Addendum No. 4

**Elevator for
Thompson High School for
Alabaster City Schools
Alabaster, Alabama**

LATHAN MCKEE PROJECT NO. 25-305A
ALABAMA DIVISION OF CONSTRUCTION MANAGEMENT NO. **2026395**

SUMP PUMP DIAGRAM - ELEVATOR DIAGRAM FOR TRACTION ELEVATOR

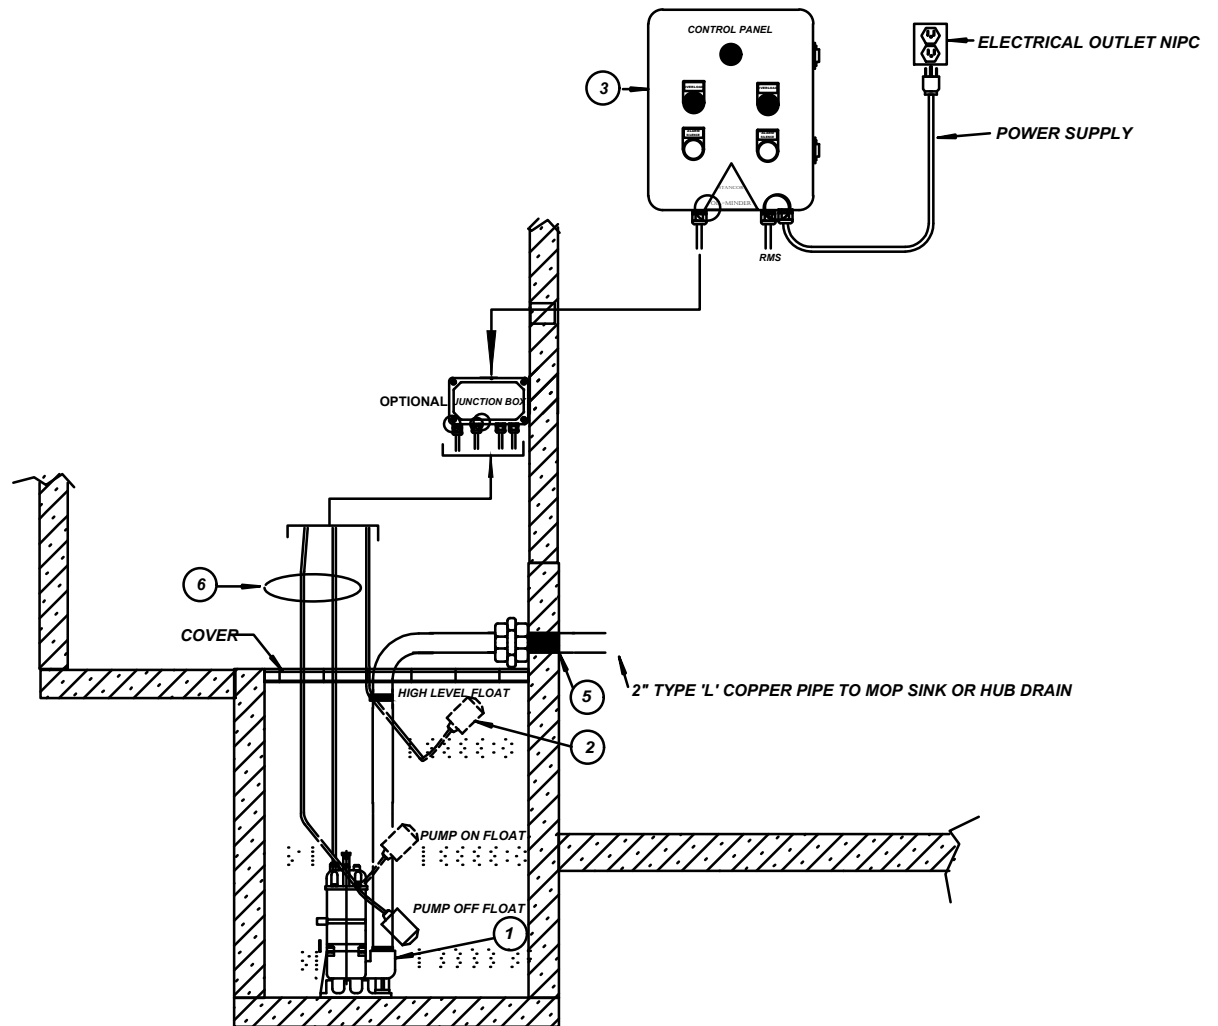
- A. See attached drawing **Sump Pump / Elevator Diagram for Traction Elevator** attached herein dated 7-21-26. The document includes the model for the pump, plumbing and electrical requirements with additional information for the installation for the sump pump system.

- ① STANCOR MODEL SE-50 SUBMERSIBLE EFFLUENT PUMP, 50GPM
.5 HP, 115 VOLT, 3600 RPM, 2" DISCHARGE CONNECTION,
- ② HIGH LIQUID ALARM FLOAT WITH CLAMP DEVICE TO
MOUNT TO PUMP DISCHARGE PIPING
- ③ STANCOR SIMPLEX OIL MINDER 115V, 1Ø CONTROL SYSTEM WITH
OPTIONAL BUILT IN AUDIBLE AND VISUAL ALARM WHEN
PUMP DOES RUN DUE TO OIL IN PIT OR HIGH
LIQUID ALARM. PROVIDE SILENCING BUTTON FOR AUDIBLE
ALARM BUILT INTO PANEL. PANEL SHALL HAVE ADDITIONAL
CONTACT FOR A REMOTE ALARM LOCATION. OPTIONAL JUNCTION
BOX CAN BE PROVIDED WITH DIN RAIL MOUNTED TERMINALS FOR
FIELD HARD WIRING
- ⑤ ALL BURIED PUMP PRESSURE DISCHARGE PIPING
SHALL BE PROTECTED WITH TAPECOAT CT CORROSION
PROTECTION TAPE
- ⑥ POWER CABLE AND HIGH
LIQUID ALARM CABLE
